**RECORD DRAWING
DECEMBER 27, 2013**

PROJECT NAME: RUTLAND SOUTHERN VERMONT REGIONAL AIRPORT
CLARENDON, VERMONT
PROJECT NUMBER: AV14-8008-300
FILE NAME: 207h124drn-RD.dgn
PROJECT LEADER: F. WALSH
DESIGNED BY: G. D'AMICO
DRAINAGE PLAN
PLOT DATE: 12/30/2013
DRAWN BY: M. KEMP
CHECKED BY:
SHEET 9 OF 29

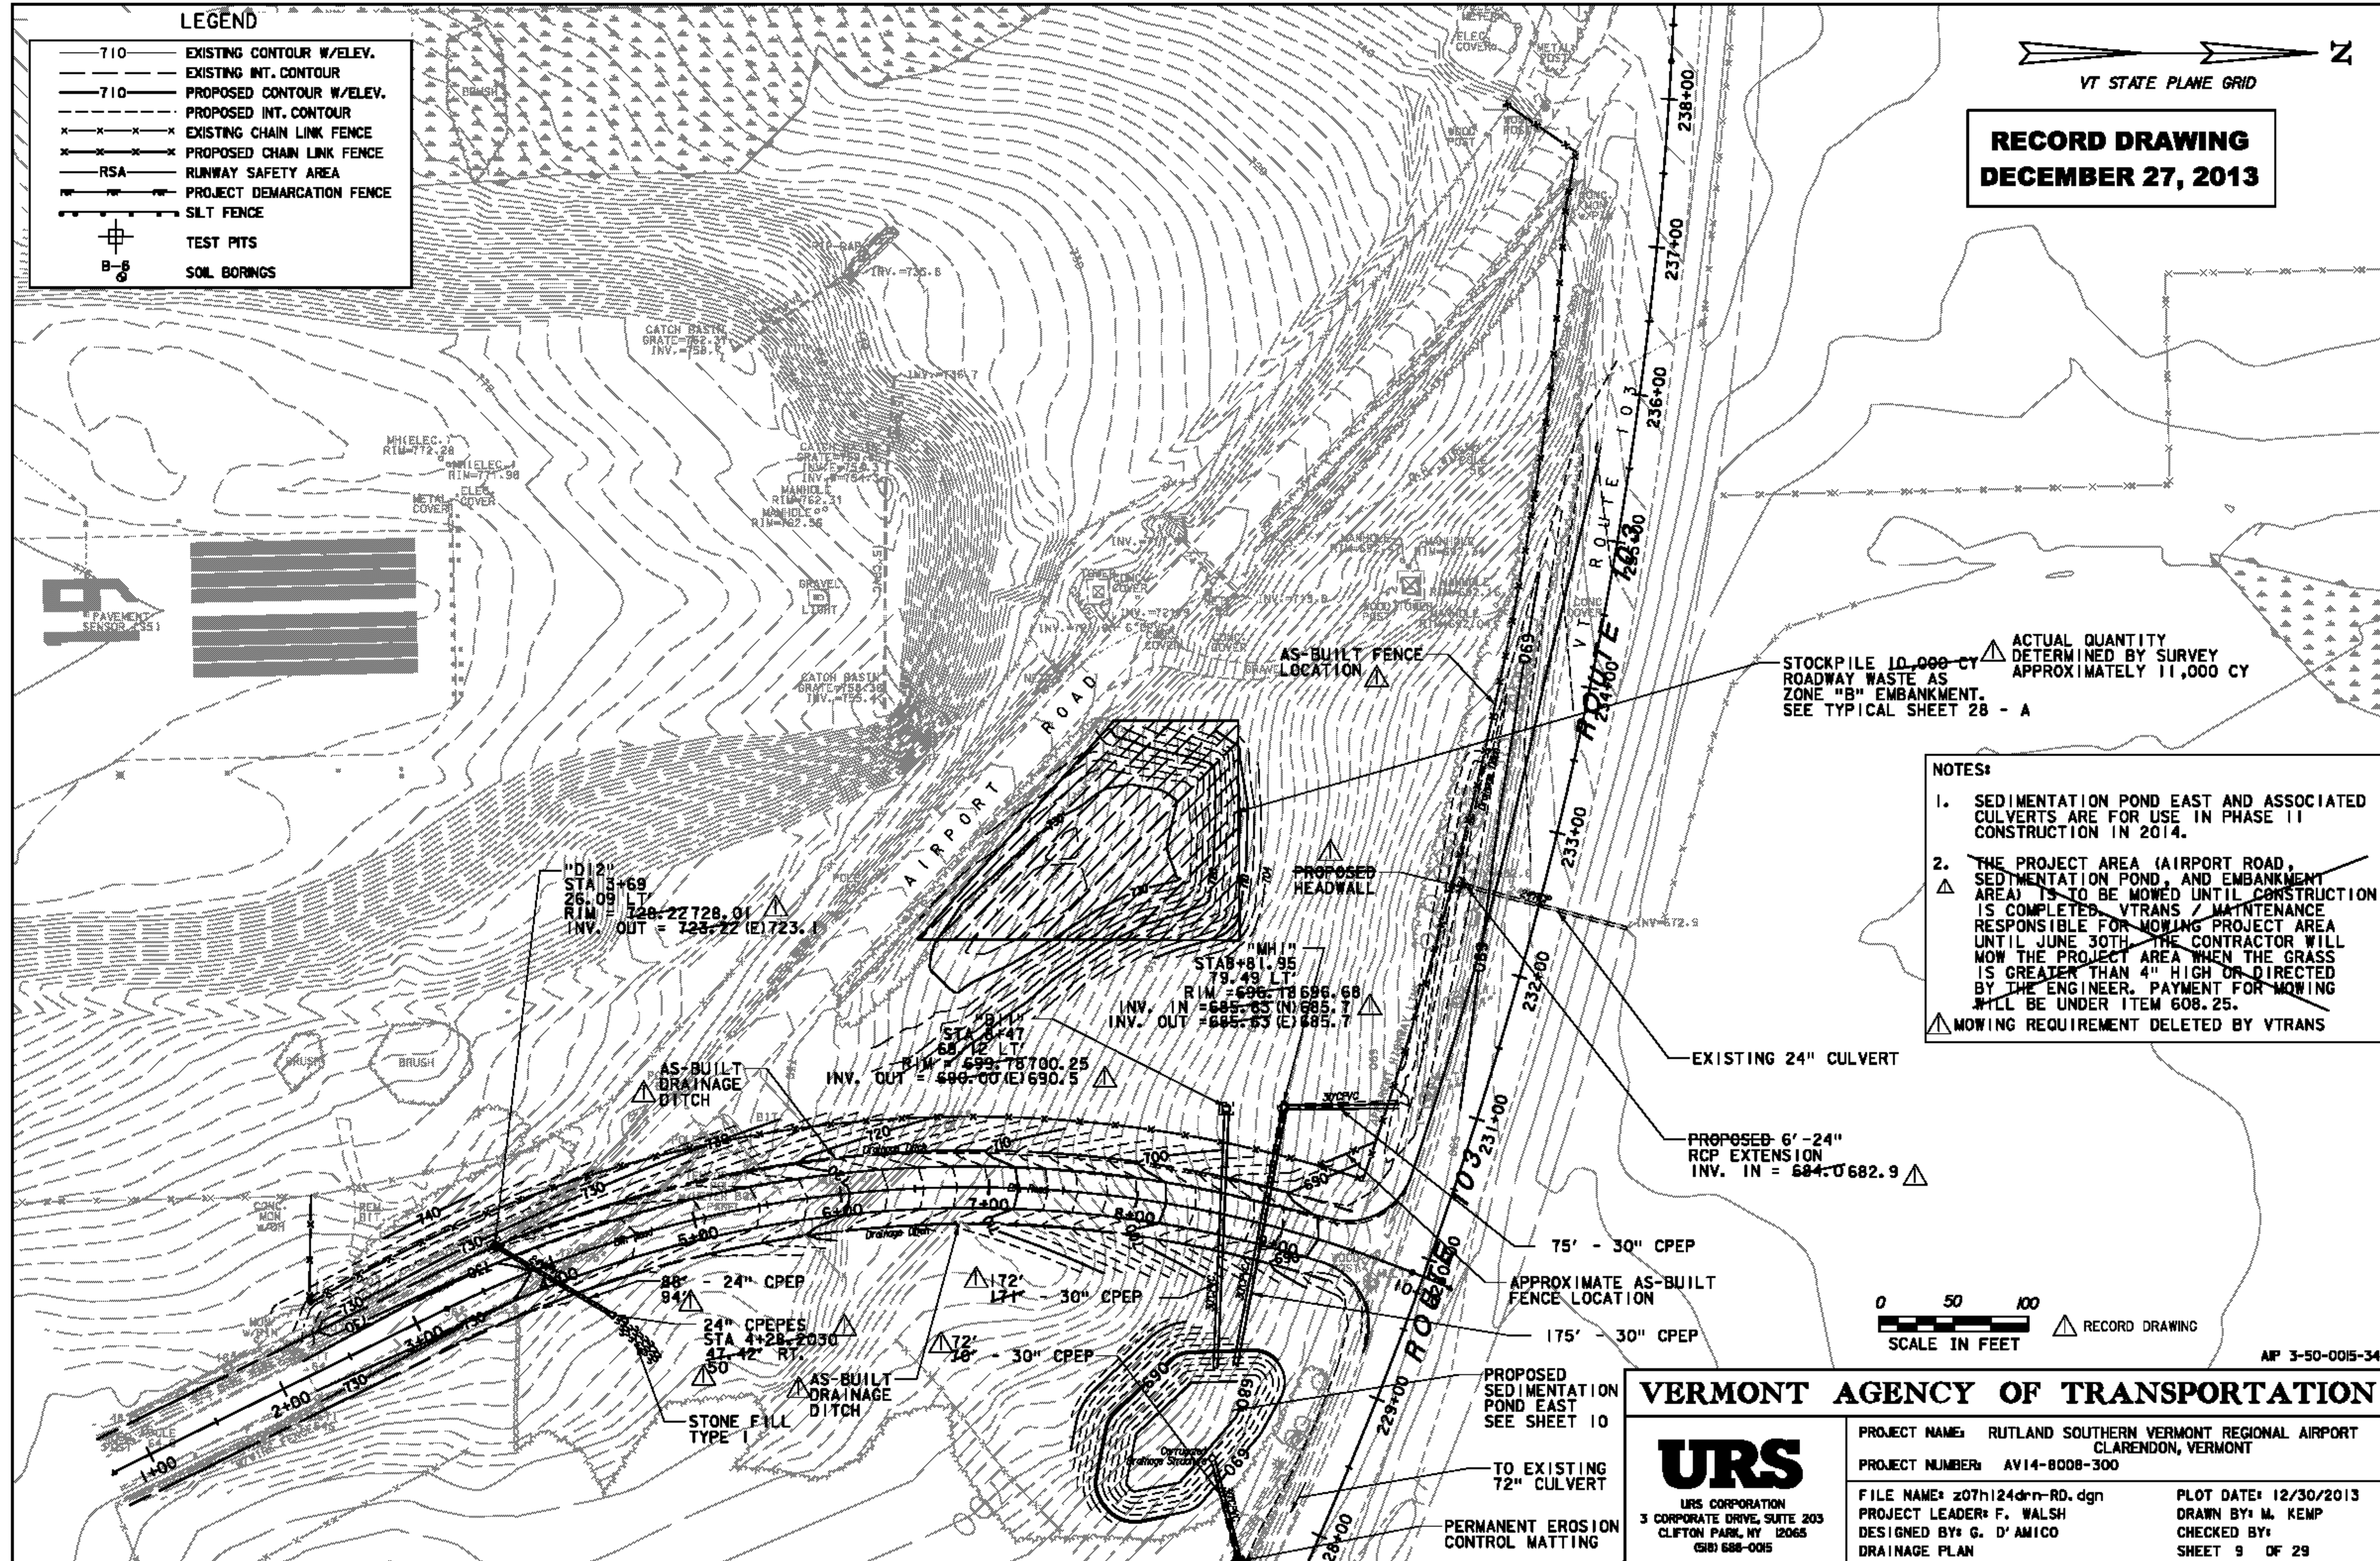
ACTUAL QUANTITY DETERMINED BY SURVEY APPROXIMATELY 11,000 CY

- NOTES:**
1. SEDIMENTATION POND EAST AND ASSOCIATED CULVERTS ARE FOR USE IN PHASE II CONSTRUCTION IN 2014.
 2. THE PROJECT AREA (AIRPORT ROAD, SEDIMENTATION POND, AND EMBANKMENT AREA) IS TO BE MOWED UNTIL CONSTRUCTION IS COMPLETED. VTRANS / MAINTENANCE RESPONSIBLE FOR MOWING PROJECT AREA UNTIL JUNE 30TH. THE CONTRACTOR WILL MOW THE PROJECT AREA WHEN THE GRASS IS GREATER THAN 4" HIGH OR DIRECTED BY THE ENGINEER. PAYMENT FOR MOWING WILL BE UNDER ITEM 608.25.
- ▲ MOWING REQUIREMENT DELETED BY VTRANS
